# UNITED STATES PATENT AND TRADEMARK OFFICE

APPLICATION NO.	FILING DATE	FIRST NAMED INVENTOR	ATTORNEY DOCKET NO.	CONFIRMATION NO.
10/534,793	05/12/2005	Robert W. Blair	02-44 US	1653
23693	7590	06/04/2007		
Varian Inc. Legal Department 3120 Hansen Way D-102 Palo Alto, CA 94304			EXAMINER NGUYEN, SANG H	
			ART UNIT 2886	PAPER NUMBER
			MAIL DATE 06/04/2007	DELIVERY MODE PAPER

# Office Action Summary

## **DETAILED ACTION**

U.S. Patent Jul. 31, 1984 Sheet 1 of 5 4,462,962

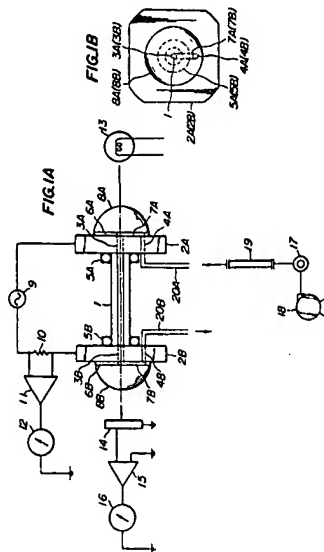
**Claim 1 is rejected under 35 U.S.C. 102(b) as being anticipated by Baba et al (U.S. Patent No. 4,462,962).**

**Regarding claim 1;** Baba et al discloses a flow through cell for, comprising:

a plurality of body members (e.g., a hollow tube [1 of figure 1A] and cell holders [2A, 2B of figure 1A]) including an intermediate body member (e.g., considered to be a

hollow tube [1 of figure 1A]) located between two other body members (2A, 2B of figure 1A), the plurality of body members (1, 2A, 2B of figure 1A) being clamped together by O-ring (5A,5B of figure 1A and col.4 lines48-52) and providing a small volume flow through passage (7A, 7B of figure 1A and col.4 lines 55-57),

wherein a part of the flow through passage (figure 1A) comprises a hole (3A, 3B of figure 1A) through the intermediate body member (1 of figure 1A) together with a liquid inlet region (4A of figure 1A) at one end of the hole (3A of figure 1A) and a liquid outlet region (4B of figure 1A) at the other end of the hole (3B of figure 1A),

wherein the two other body members (2A, 2B of figure 1A) are each associated with an optically transparent window (8A,8B of figure 1A) aligned with a respective end of the hole (3A, 3B of figure 1A) through the intermediate body member (1 of figure 1A) thereby providing an optical pathway (figure 1A, e.g., from the light source [13 of figure 1] to photodetector [14 of figure 1]) through said part of the flow through passage (figure 1),

wherein the liquid inlet and liquid outlet regions (4A, 4B of figure 1) are provided by respectively, a portion of the flow through passage (7A, 7B of figure 1) through which liquid flows into or out of a said region substantially immediately adjacent the optically transparent window (8A, 8B of figure 1) transversely of the direction of the hole (3A, 3B of figure 1). See figures 1-5.

**Regarding claim 5;** Baba et al discloses at least the intermediate body member (1 of figure 1), or at least each of the other two body members is resilient to provide for sealing contact (5A, 5B of figure 1) between adjacent body members (2A, 2B of figure 1). It is noted that the language of the present invention "at least the intermediate body member, or at least each of the other two body members" is alternative (optional). For the purposes examination, this feature chooses "at least the intermediate body member".

**Regarding claim 6;** Baba et al discloses the optically transparent window (8A, 8B of figure 1) associated with each of the other two body members (2A, 2B of figure 1).

is a window assembly sealingly mounted within a hole (3A, 3b OF FIGURE 1) in a body member (2a, 2b of figure 1).

**Regarding claim 7;** Baba et al discloses the optically transparent window (8A, 8B of figure 1) associated with each of the other two body members (2A, 2B of figure 1) is provided by respectively a transparent plate (6A, 6B of figure 1) sandwiched between the intermediate body member (1 of figure 1) and one of the other body members (2A, 2B of figure 1).
